Subject: Revision 1 to Transnuclear, Inc. (TN) Application for Amendment 2 to the Standardized Advanced NUHOMS<sup>®</sup> System (Docket No. 72-1029; TAC NO. L24056)

Reference: Letter from Jessica M. Glennly (NRC) to Donis Shaw (TN), "REQUEST FOR ADDITIONAL INFORMATION FOR REVIEW OF AMENDMENT 2 TO THE STANDARDIZED ADVANCED NUHOMS<sup>®</sup> SYSTEM (TAC NO. L24056)," October 17, 2007

**RAI Responses**

**Figure 4-1 Minimum Spacer Disc Ligament Widths**

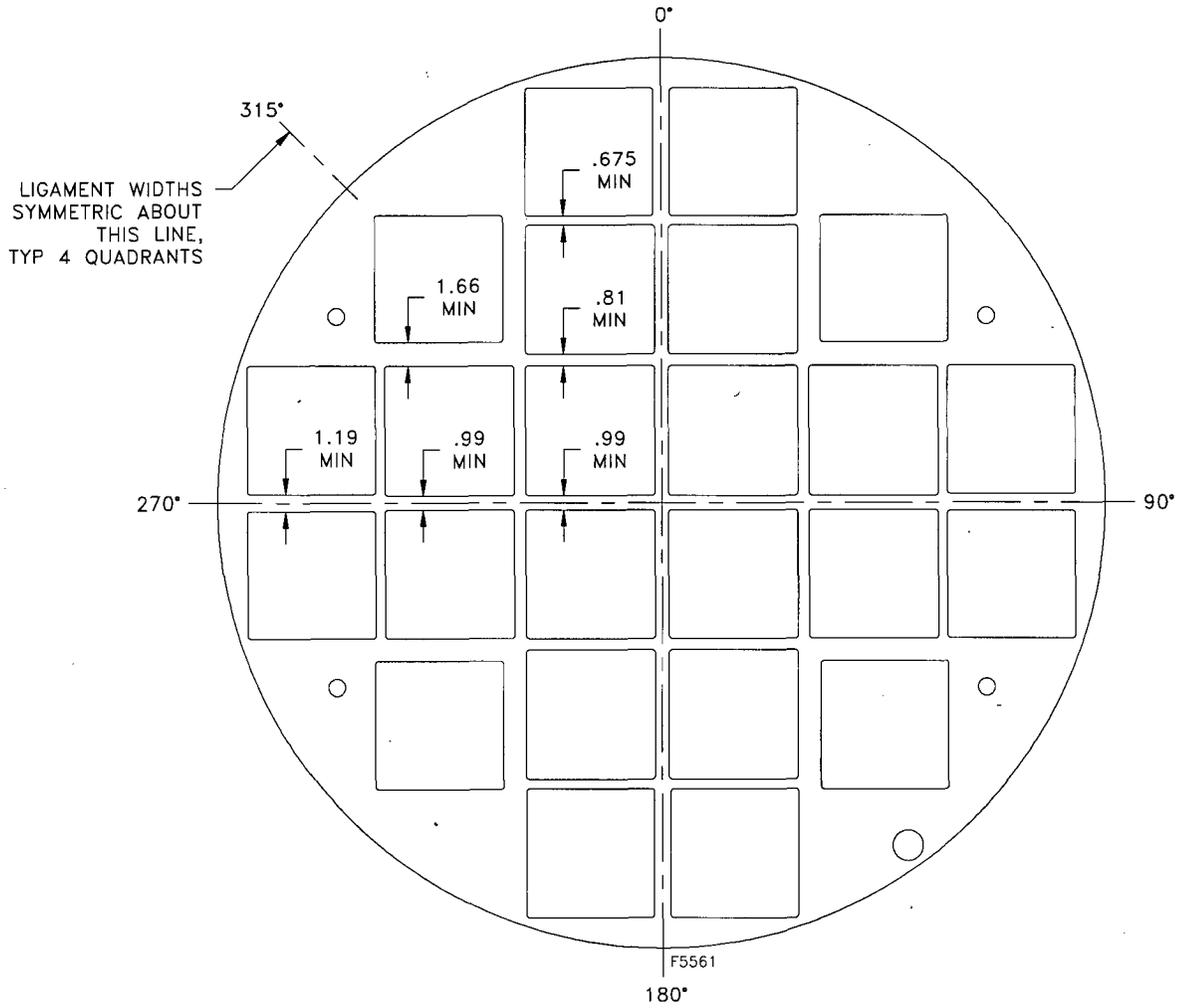
TS-7 Provide the units for the dimensions specified in TS Figure 4-1.

TS Figure 4-1 defines the minimum ligament width dimensions for the canister flux trap configuration. This information is important for criticality safety purposes, and the dimensions, including the units, should be consistent with the criticality analysis for both the 24PT1-DSC and the 24PT4-DSC. However, the units (e.g., inches) are not specified on the figure in the proposed amendment. Staff notes that the units were specified as inches in the TS for the initial certificate.

The units used in TS Figure 4-1 are "inches". The TS Figure 4-1 is revised to add this unit to the dimensions.
